## 31 Glenvale Road Newtown

### Response to Council Information Request – Transport and Traffic Items

Urbis has been engaged to respond to the traffic and transport items within the Toowoomba Council information request (IR) for the proposed multiple dwelling development at 31 Glenvale Road, Newtown. The Council reference is MCUI/2026/1261, and the IR notice is dated 16<sup>th</sup> March 2026.

Figure 1: Proposed Traffic and Waste Changes to Plan

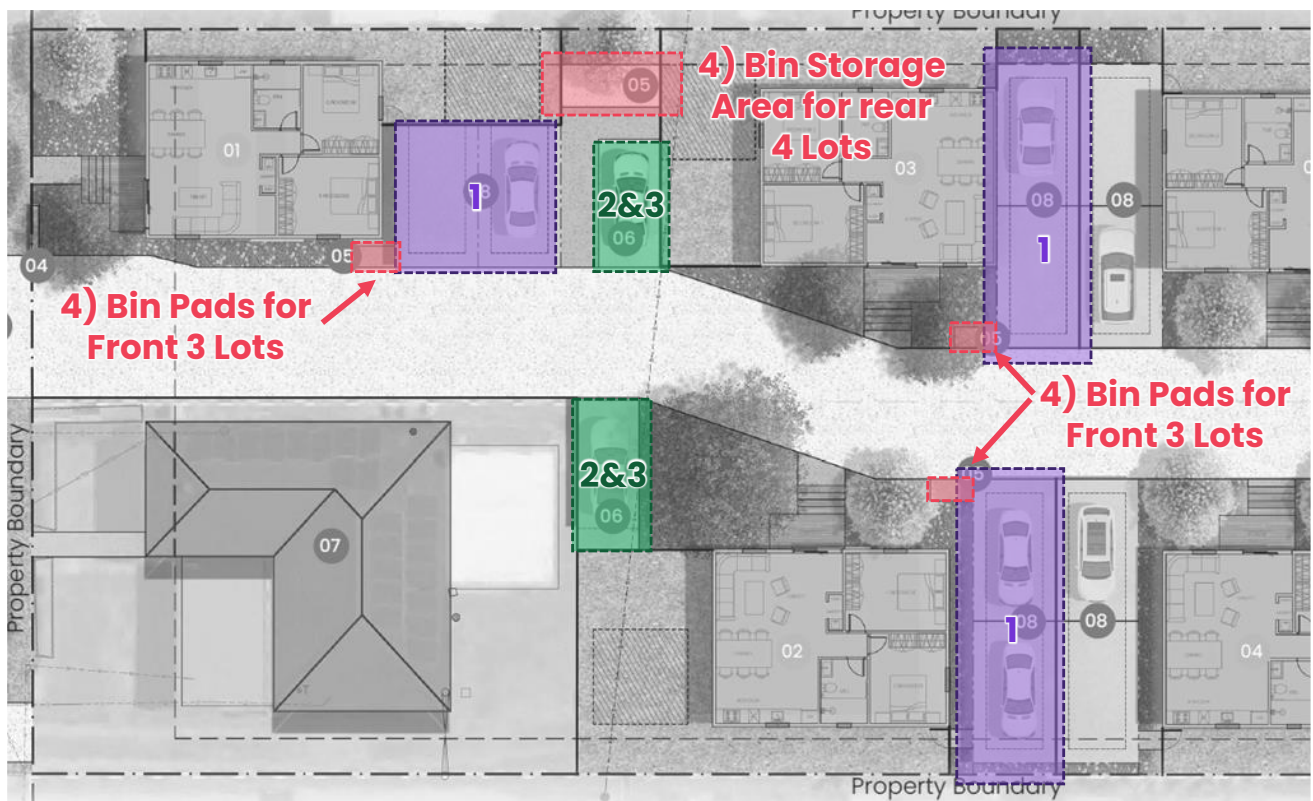
The proposed development plans have been updated in response to the IR issued by Council. The following traffic-related changes are noted:

1. The residential parking bays for the front three proposed lots (Units 1, 2 and 3) have been relocated in response to visual amenity and street frontage concerns raised by Council.
2. Visitor parking bays have been relocated to behind the front lot instead of directly visible from the street and are now provided on either side of the parking aisles.
3. The visitor bay width has been increased to a minimum of 2.9m.
4. Bin storage area has been reconfigured, with individual sealed pads located separately within each of the front three proposed units and a shared bin storage area provided for the rear four lots located adjacent to the western visitor parking bay. This is to optimise travel distance for residents.

Provide amended plans showing the visitor carparking relocated away from the frontage of the site and integrated into the site layout as to not be dominant visual feature when viewed from Glenvale Road.

Provide amended plans to demonstrate a refuse storage area in accordance with the requirement outlined in the Planning Scheme.

The visitor parking bays have been relocated to beyond the first row of units. Table 1 identifies the design review against the requirements:

As noted in Figure 1, the updated plans have included dedicated bin arrangements for each lot:

- **Existing dwelling:** retained as per existing arrangement, located within the lot.
- **Front three proposed units (Units 1-3):** individual bin pads are located adjacent driveway and resident parking spaces for the individual lot. Each bin pad measures 0.9m (d) x 1.8m (w), which aligns with the minimum bin storage dimensions for two standard 240L bins (0.73m (d) x 1.34m (w)) as per Council's Technical Guideline for New Developments – General Waste and Recyclable Waste Storage and Collections.

- Rear four proposed units (Units 4-7):** a shared bin storage area is located adjacent to the western visitor parking bay. The bin pad measures 1.8m x 4.4m, which aligns with the minimum bin storage dimensions for eight bins (in configuration of two rows x four bins minimum 1.46m x 2.68m).

Figure 2 Bin Collection Location

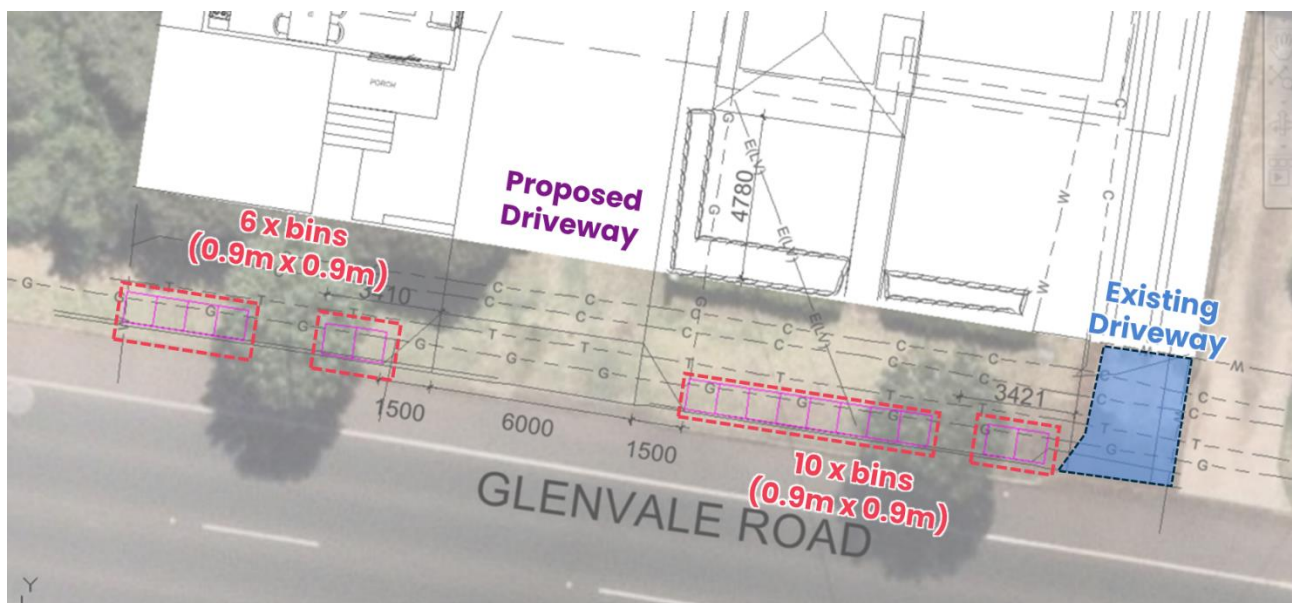
AO1.2 of the Medium Density Residential Code requires that the site design retains all existing street trees. Two existing street trees are located along Glenvale Road within the frontage of the site. The proposed driveway crossovers are in proximity to these street trees. Insufficient information has been provided to ensure the crossovers won't adversely impact the existing street trees.

The driveway width (6.0m) is compliant with the minimum required widths, as outlined in the Traffic Impact Assessment dated 13 Feb 2026. This ensures suitable access for vehicles entering and exiting the site. The driveway is located at least 1.5m from the edge of the existing street trees which provides sufficient clearance to not impact the trees.

Furthermore, as demonstrated on Figure 2, there will be sufficient length for the bins to be presented along the kerb without impacting on driveways or street trees. As illustrated on Figure 3, residents are currently locating bins near / under the street tree indicating the suitability of this placement.

EXISTING DWELLING - IN

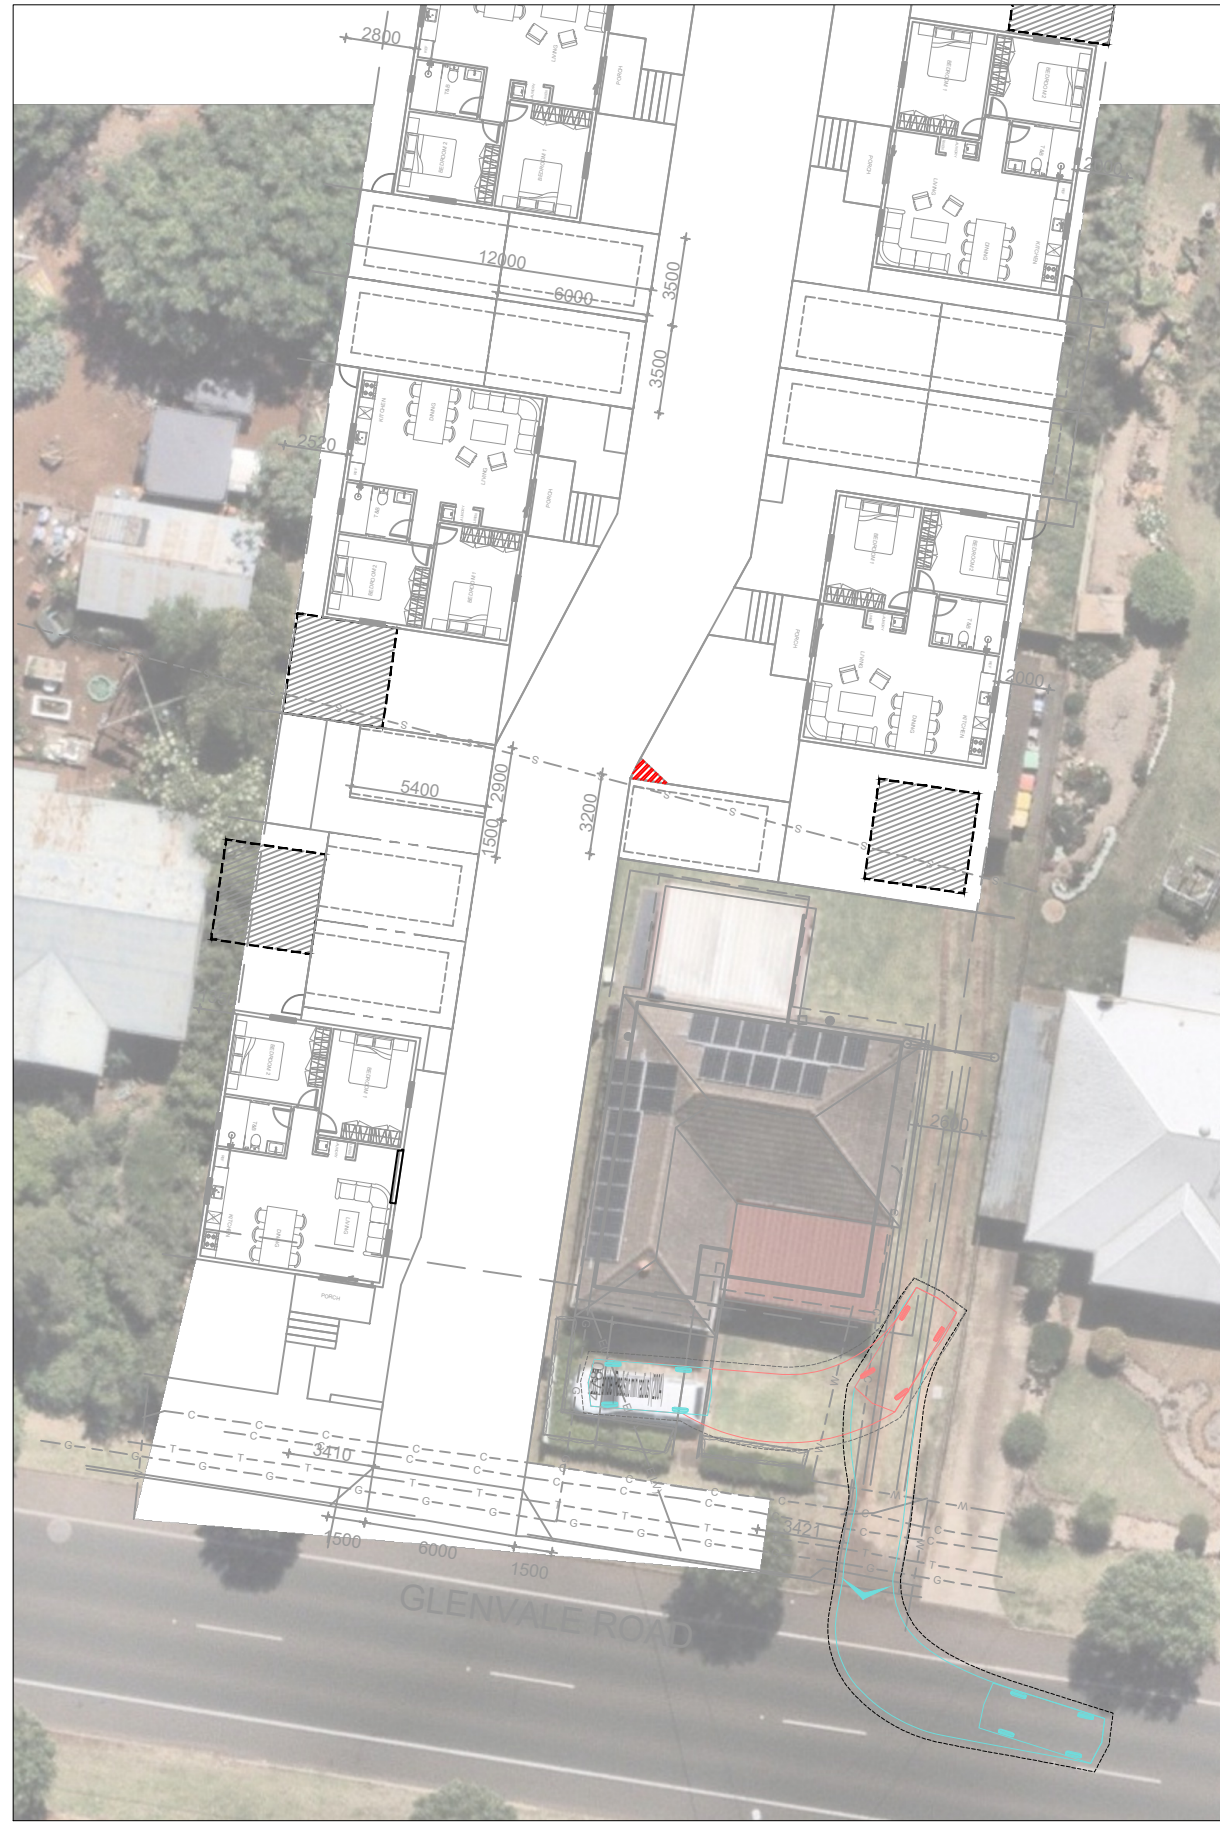
*A development that reuses the existing dwelling as a unit is supported in principal. The existing dwelling should be better integrated by consolidating access and parking where possible. A second driveway crossover with reverse entry or exit is not preferred. This also limited kerbside area available for presentation of bins.*

*Provide amended plans demonstrating integration of the existing dwelling maximising the available kerbside space.*

The proposed arrangement allows the existing dwelling to continue to operate as a standalone use, with seven new units. As no changes are proposed to the existing dwelling, the provision of a separate driveway is required and does not impact the existing driveway arrangement.

- No reverse entry or exit movements are proposed. Cars can enter and exit the site in a forward gear, as demonstrated on swept path drawing SK06 (enclosed at **Appendix C**).
- As noted in the TIA report, sufficient frontage is available to place bins along the kerb on collection days.

Figure 1: Proposed Changes to Plan

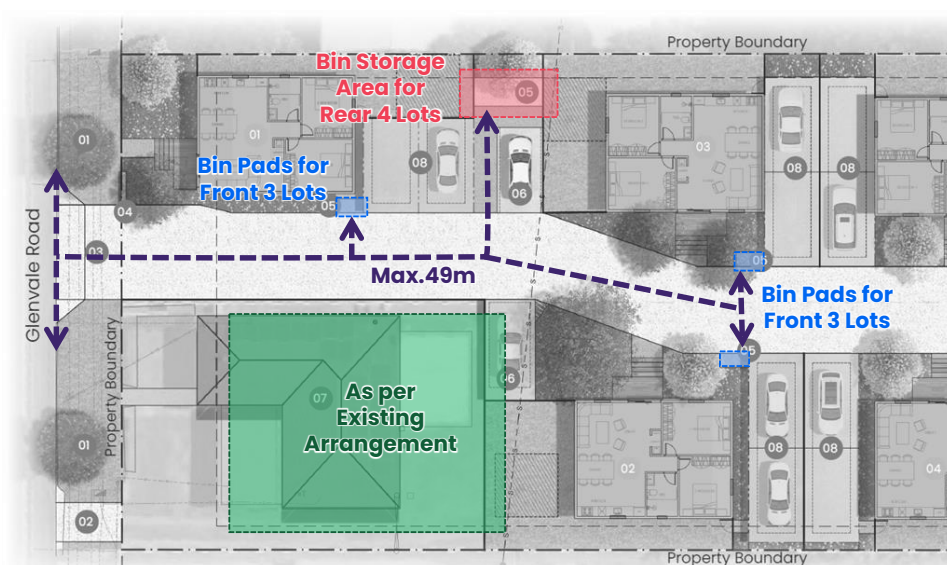
*Provide a Detailed Waste Management Plan.*

- **Existing house:** as per existing arrangement, located within the lot.
- **Front three proposed units (Units 1-3):** individual bin pads are located adjacent driveway. Each bin pad measures 0.9m (d) x 1.8m (w), which aligns with the minimum bin storage dimensions for two standard 240L bins (0.73m (d) x 1.34m (w)) as per Council's Technical Guideline for New Developments – General Waste and Recyclable Waste Storage and Collections.
- **Rear four proposed units (Units 4-8):** a shared bin storage area is located adjacent to the western visitor parking bay. The bin pad measures 1.8m x 4.4m, which aligns with the minimum bin storage dimensions for eight bins (in configuration of two rows x four bins minimum 1.46m x 2.68m).

The location of the bin storage area is shown below in Figure 1. As indicated on the figure, the travel distance between the bin storage and collection areas is less than the Council's requirement of 50m
